Docket Number:	07-AFC-06C
Project Title:	Carlsbad Energy Center - Compliance
TN #:	203300
Document Title:	Project Owner Responses to Data Request Set 3 (Nos. 67-84)
Description:	N/A
Filer:	Dee Hutchinson
Organization:	Locke Lord LLP
Submitter Role:	Applicant Representative
Submission Date:	10/31/2014 3:33:13 PM
Docketed Date:	10/31/2014

Re: Carlsbad Energy Center Project Petition to Amend (07-AFC-06C)
Responses to Data Request Set 3 (Nos. 67–84)

Data Response Set 3 (Response to Data Requests 67 to 84)

FIGURE 2.0-1R1
Site Plan
Carlsbad Energy Center Project
Carlsbad, California (07-AFC-06C)
Petition to Amend

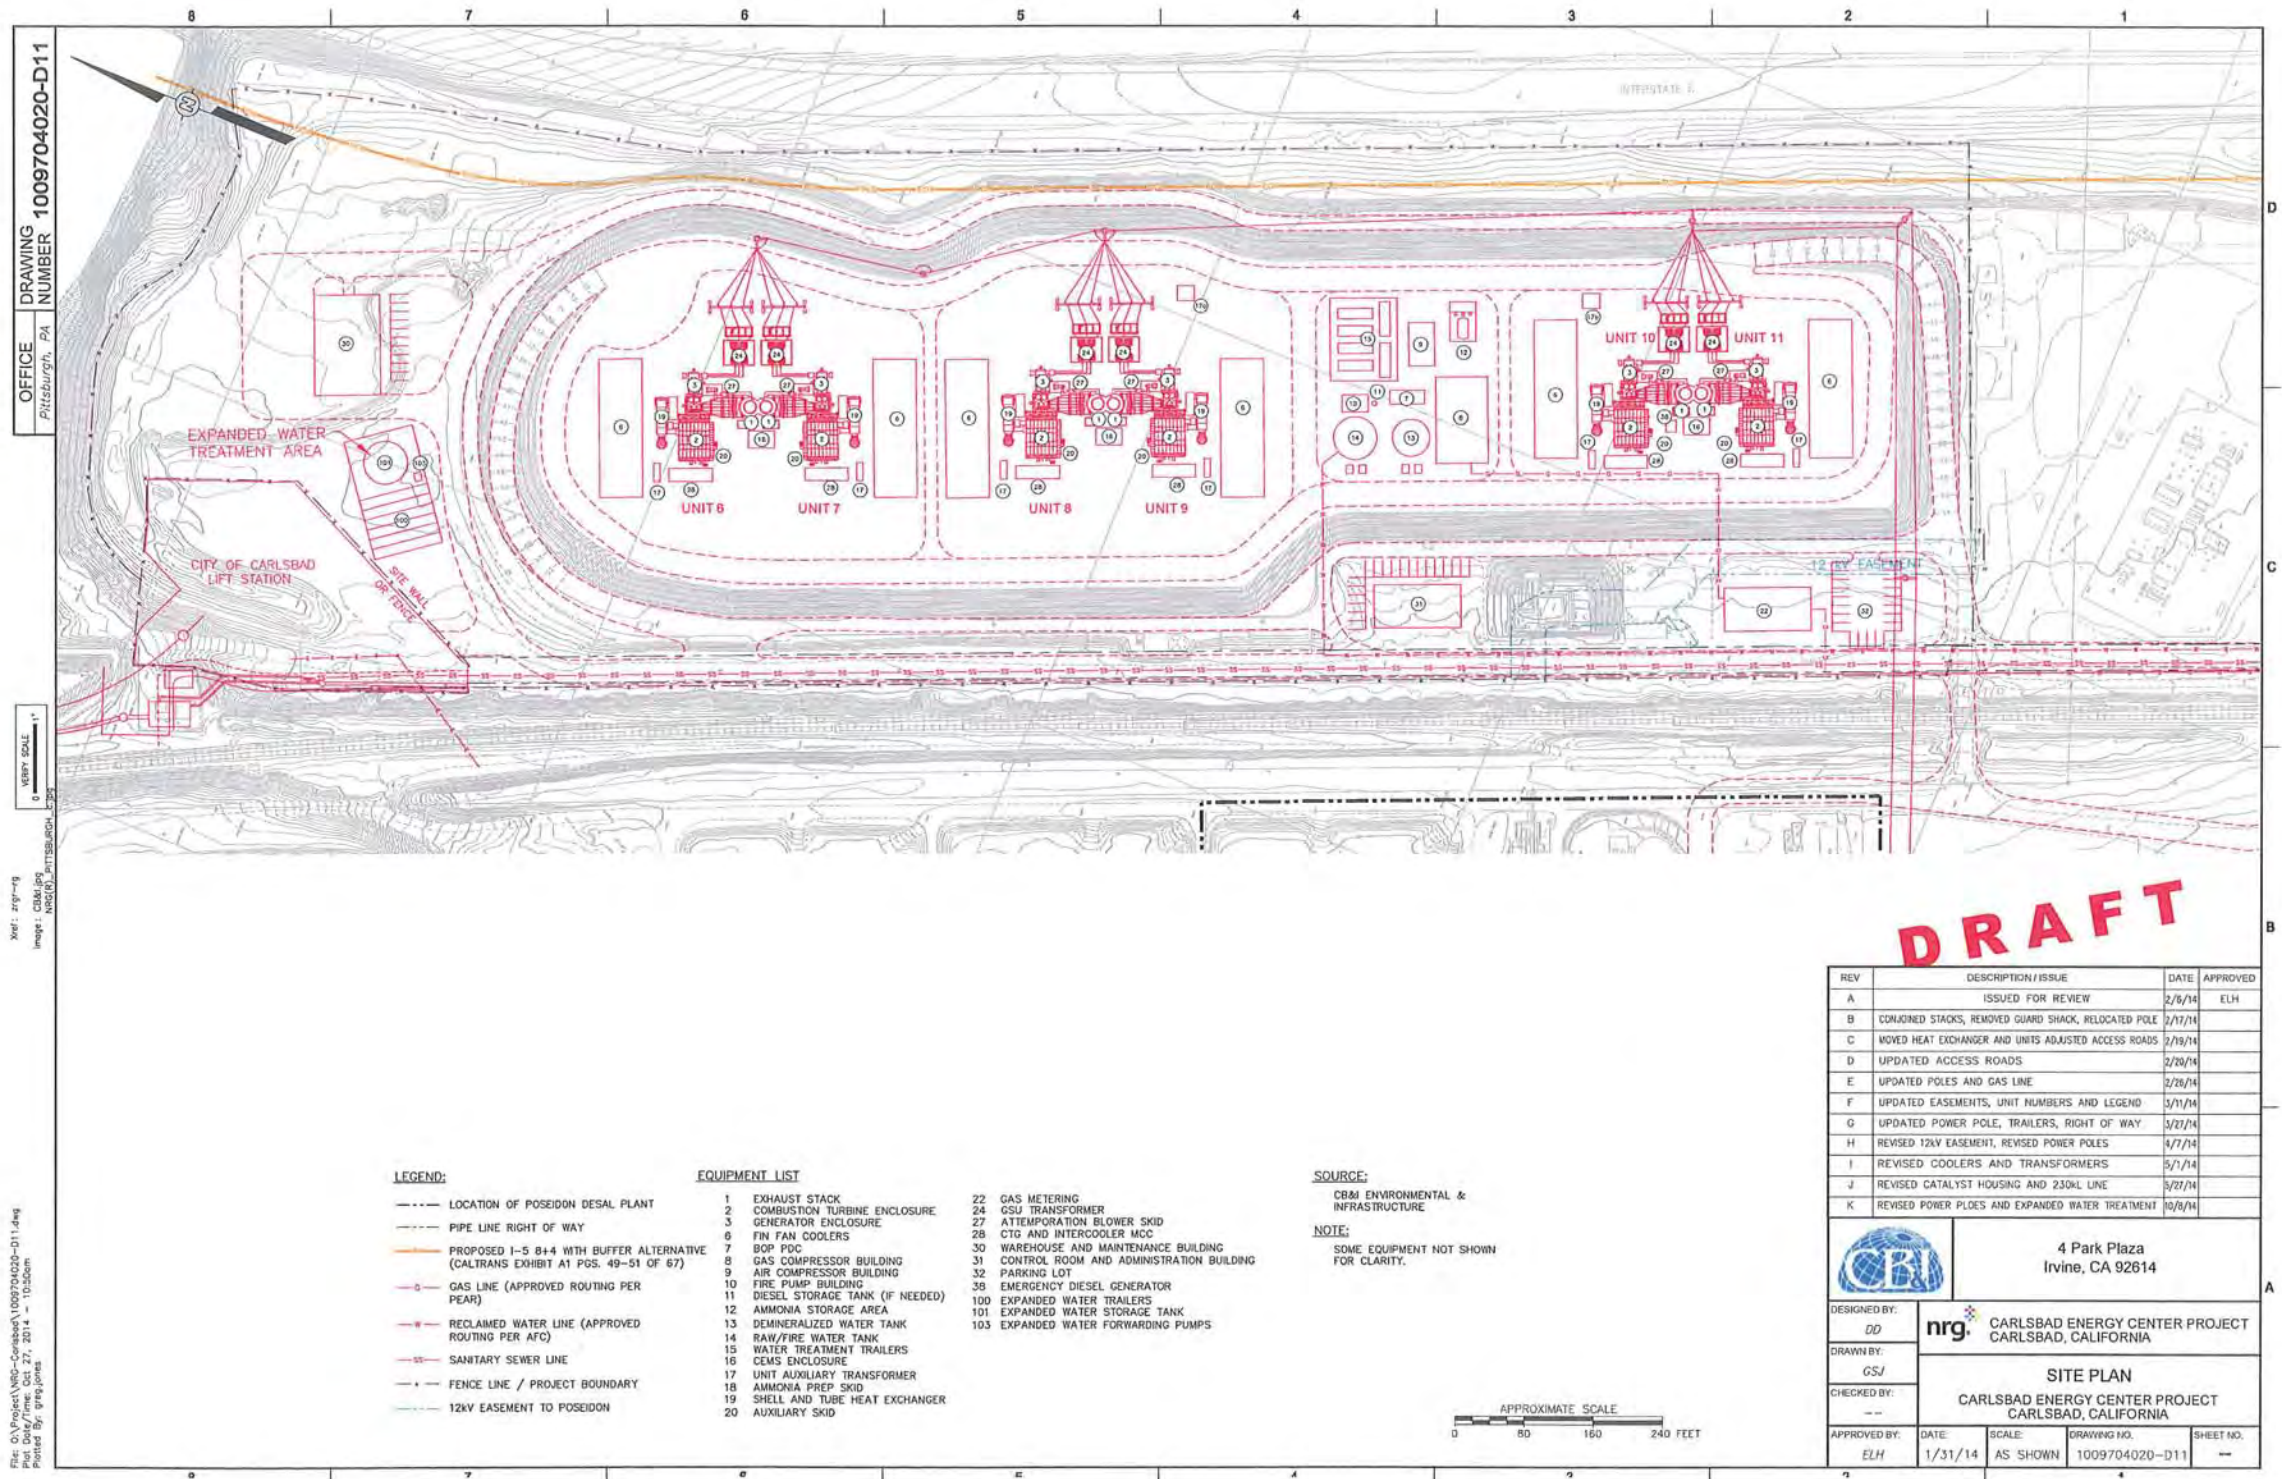
Additionally, the site plan (PTA Figure 2.0-1), plot plan (PTA Figure 2.1-1), and transmission line routing (PTA Figure 3.1-1) are revised and included in this data set.

- Location change of two northern poles now re-located in to the lower berm area

- An addition pole has been added to the northern section of the transmission line and located within the berm
- Elimination of the OWS (Ocean Water System)
- The area previously allocated to OWS, repurposed for additional water treatment.

The scale on these drawings has been vetted against known sizes of equipment onsite. Figure DR74-2 has been added to show the CECP overlay on the existing features of the site .

FIGURE DR22-2R1
Takeoff Structure
 Carlsbad Energy Center Project
 Carlsbad, California (07-AFC-06C)
 Petition to Amend

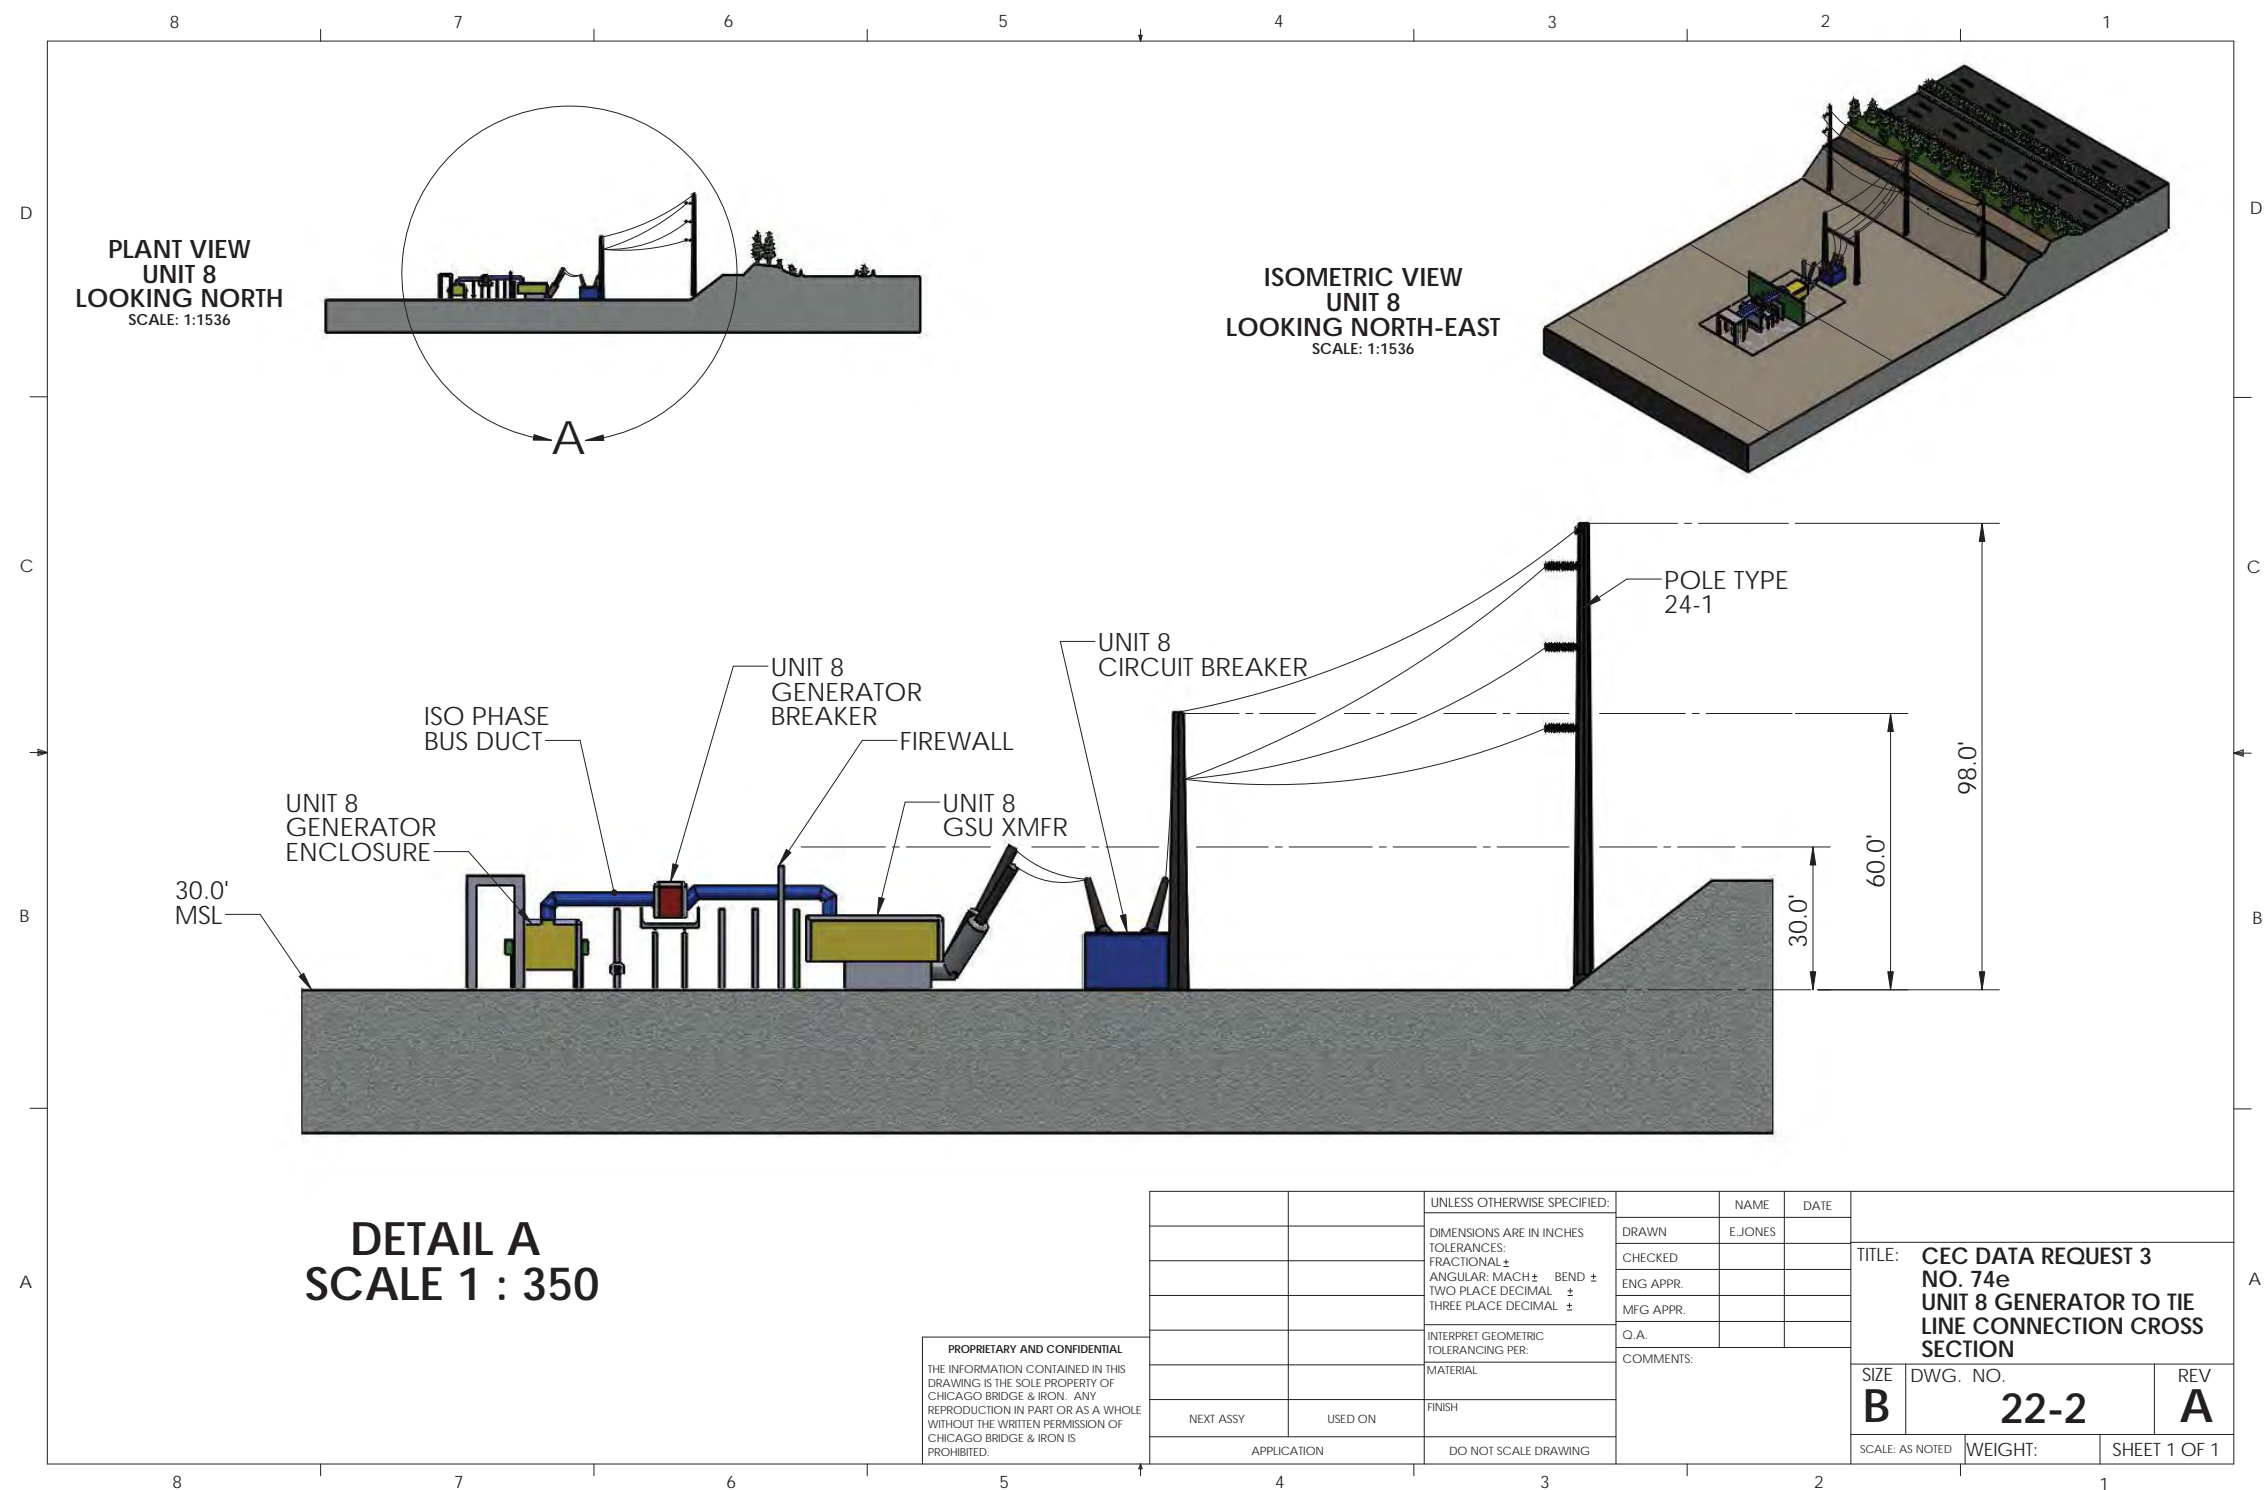
- e. Please provide detailed 3-phase diagram(s) (plan and side view) showing positions of the two H-pole take-off structures (refine Figure DR 22-2) for the gen unit outlet lines in each amended CECP switchyard, the transitions between gen outlet lines and gen tie line(s) in the line dead end pole.

74e. Figure DR22-2 has been revised to show a 3 dimension view starting from the generator enclosure to the transmission line pole.

FIGURE DR24-1R1
Transmission Line Pole Cross Section
Deadend Steel Pole
Carlsbad Energy Center Project
Carlsbad, California (07-AFC-06C)

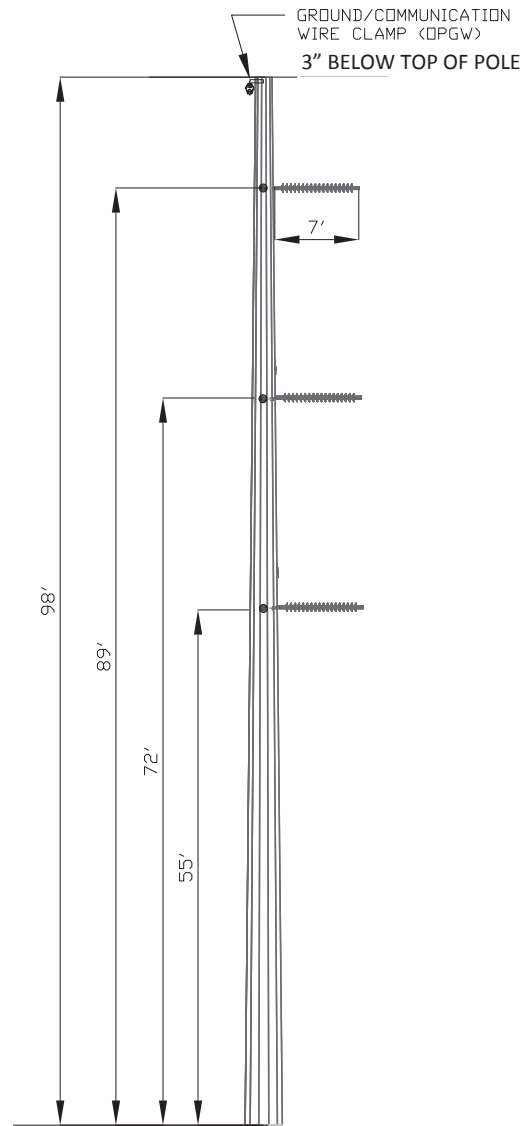
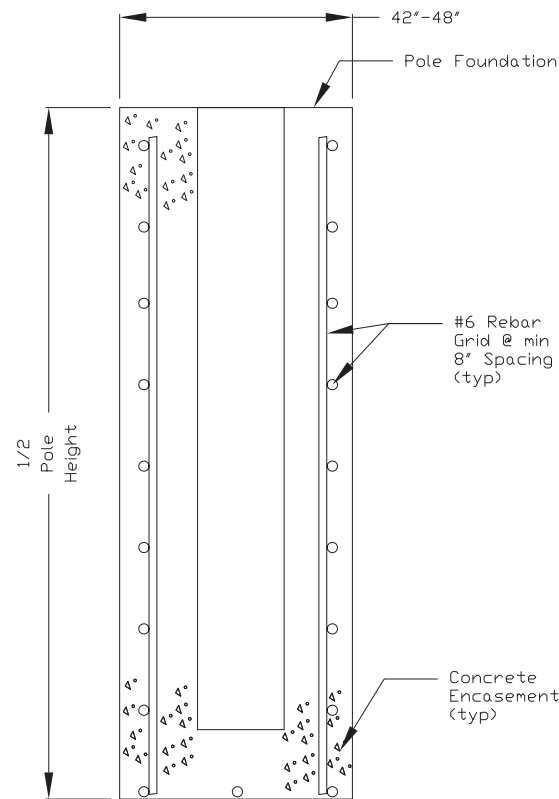
- 75 Resubmit Steel pole Figures 24.1, 24.2 and 24.3 showing the specific locations of the ground wire (size: ½ inch EHS steel), and any required communication cable/wire, include their respective clearances from the ground level.

Figures DR24-1, DR24-2, and DR24-3 have been revised to depict OPGW (Optical Ground Wire) on the pole structures.

REV	DESCRIPTION / ISSUE	DATE	APPROVED
A	ORIGINAL ISSUE	07/12/2007	n/a
B	ADDED LOCATION OF GND WIRE	10/15/2014	DRD
